23/57-00A REV. 4501 Olney- ^Ř Laytonsville Road (Falling Green)

OBGC COMMUNITY PARK PLANT LIST: PHASE 1

DONOVAN TREE PLANTING PLAN FEOLA BALDERSON & ASSOCIATES, INC. LANDSCAPE ARCHITECTURE SITE FLANNING FOREST CONSERVATION PLANNING RECREATION PLANNING OBGC COMMUNITY PARK MONTGOMERY COUNTY, MARYLAND 19110 MONTGOMERY VILLAGE AVENUE SUITE 210 MONTGOMERY VILLAGE, MARYLAND 20886 301-258-7778 301-948-6934 (FAX) DATE:1/21/2002 BCALE: 1"-100' BY:

SUBJECT: Historic Area Work Permit 23/57-00A REVISION

This is a simple scetch of The buildings. All are Typical. IF There is any thing else you Need, Please cell.

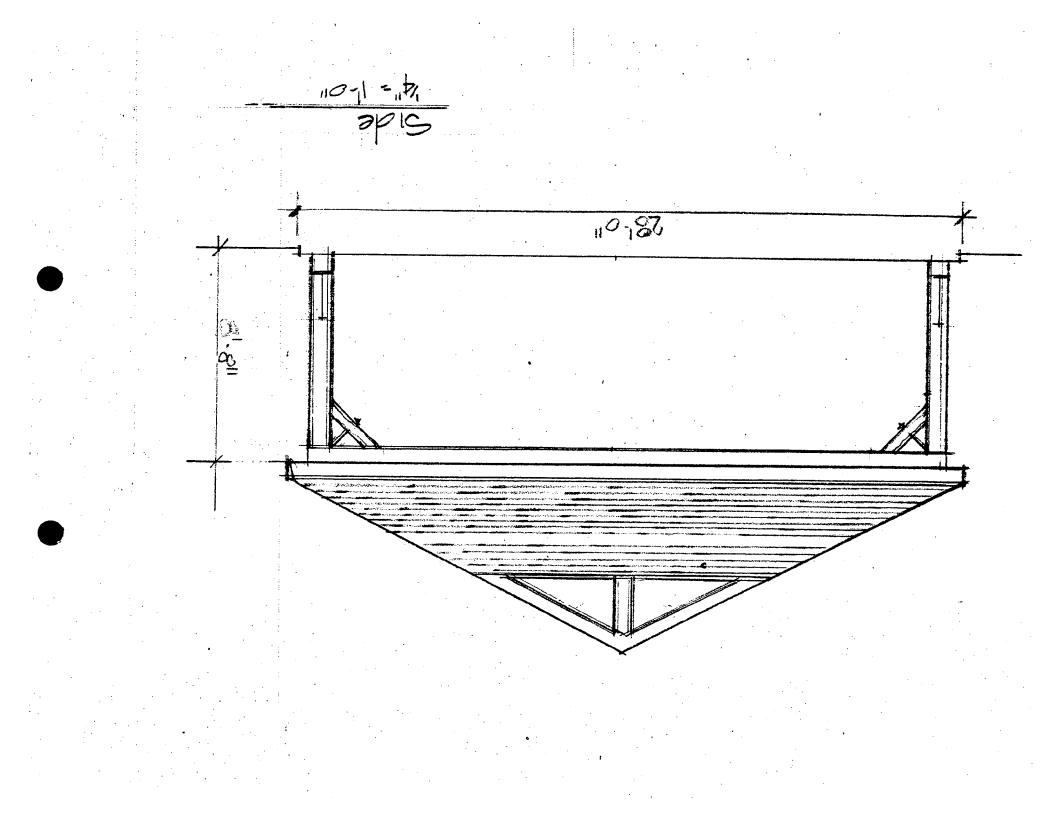
Staff feels that the proposed buildings look like generic park buildings rather than accessory agricultural buildings one might associate with Falling Green. Staff supports the introduction of three accessory structures to the site, of this size, scale and materials. But staff feels the design should be modified to reflect more typical farm buildings (see Circle 28 - 33). The foundation coursing of concrete block should be reduced, and the amount of wood siding should be increased. The board-and-batten siding could be acceptable, but staff feels the spacing of the battens should be reduced to maintain the small scale of the structure. Horizontal siding could also be acceptable, in light of the fact that the barn (which is presently being reconstructed) had horizontal siding. But a diversity of siding types on the one site would also be acceptable.

Staff feels strongly that the roof form for these accessory structures should be simplified, to reflect simple rectangular structures with either simple porch overhangs (see Circle 2%, $3\circ$, 3i) or porch-like overhangs. In addition, the pitch may be increased. A break in the roof pitch would not be atypical, if done in a simple manner (see Circle 33). Also, the buildings could be designed as a two-part structure (see Circle $32\cdots$), more closely reflecting their program. The applicant should also provide information about the openings: will there be windows or painted plywood panels? What do the doors look like? Is there paving around the buildings, or just in front of the concession area? Is there pole lighting around these buildings, or will the parking lighting be sufficient? The type of fencing proposed is typical farm fencing and staff supports this. The pending site plan should provide more specific information as to the location of the fencing. Staff notes that farms used fencing programmatically, within the confines of the farm and not just as edging along the property boundaries, and meets the needs of the OBGC. They would prefer leaving the board unpainted/unstained to weather, and staff would support this, while noting that painted fencing could be viewed as more in-keeping with the high status of the original owners of Falling Green, reflecting, as well, their desire to protect the fencing from the sun and weather.

- 4. Coach lamps have been deleted from entry signs and gate by owner.
- 5. Outbuildings will be modified to more closely reflect typical farm buildings. This may be worked out with staff level approval.

Left Entry Feature Elevation - 1'-1'-0"

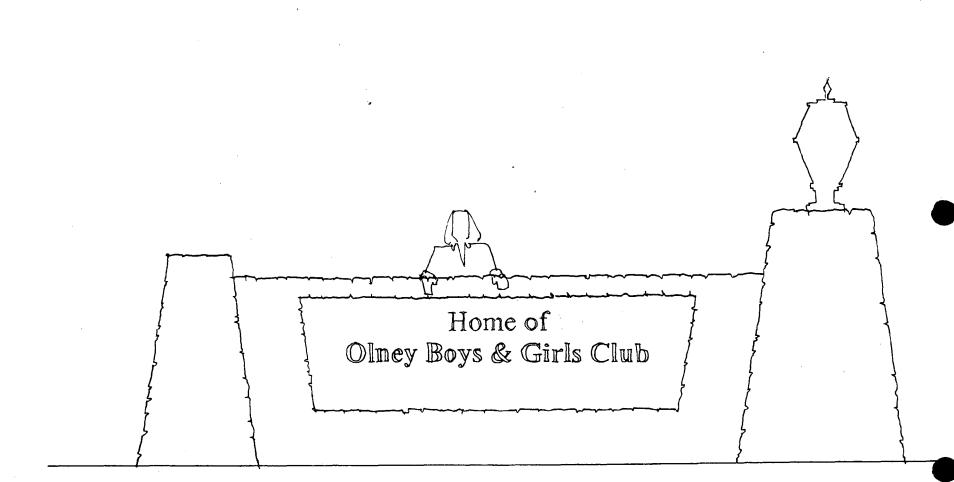
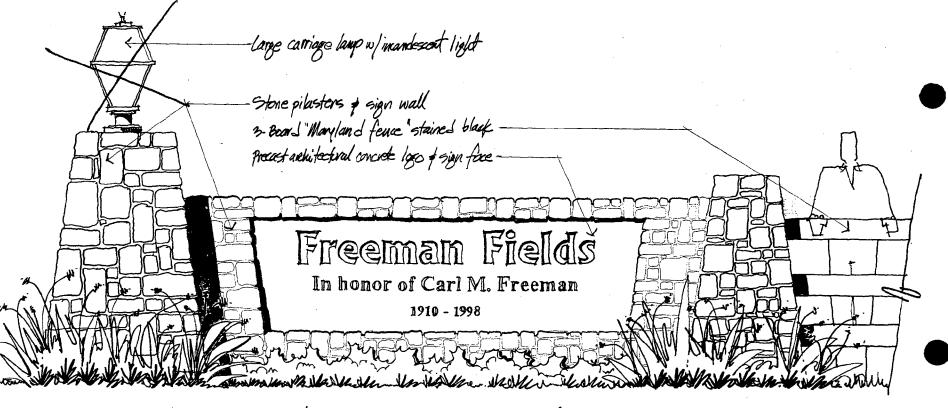
- 4. Coach lamps have been deleted from entry signs and gate by owner.
- 5. Outbuildings will be modified to more closely reflect typical farm buildings. This may be worked out with staff level approval. - Close to Im Concept of The FARM Simpler Roof lines.

Large signs are proposed on either side of the entry road (see Circle $\& q_{-1} v$). They measure approximately 16' long x 4' high. They consists of a stone panel spanning between two stone posts. The stone will be salvaged from a dumping site on the property. The stone may relate to a demolished building and also stone cleared out of the crop fields. This is similar to the fieldstone which was used for the barn foundation. The two signs reflect the current owner, as well honoring the longterm support of Mr. Carl M. Freeman. The carriage lamps which are shown on the drawing have been verbally deleted by the applicant, and appear to be unnecessary because of the required post lighting along the entry road.

Deleted by dumer

Home of Olney Boys & Girls Club FALLING GREEN, est. 1764 try Feature Elevation - 1"=1-0" HPC STAFF REVISION PROPOSED. } `
